Susquehanna Training Center
P.O. Box 467
Berwick, PA 18603
717-542-3353

Susquehanna Training Center
SRO Examination
PLA 0005112 Files A14-13D, R41-2

The following changes were made to Rev 0 of the Susquehanna written SRO License Exam and are included in the attached copy of the proposed exam.

54. Which condition below requires a change in mitigation strategy with regard to adequate core cooling?

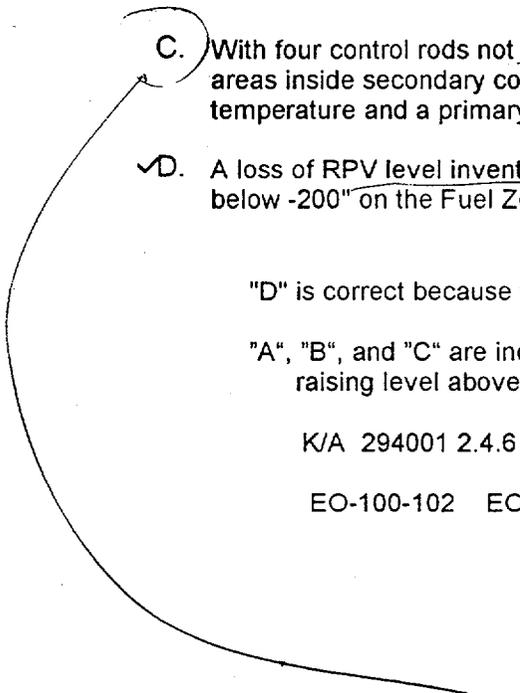
EO-113 / EO-104?
What Strategy are you implementing here? Doesn't seem consistent. Doesn't "C" require a change in Strategy?

C & D
Plan for
try add
strategy
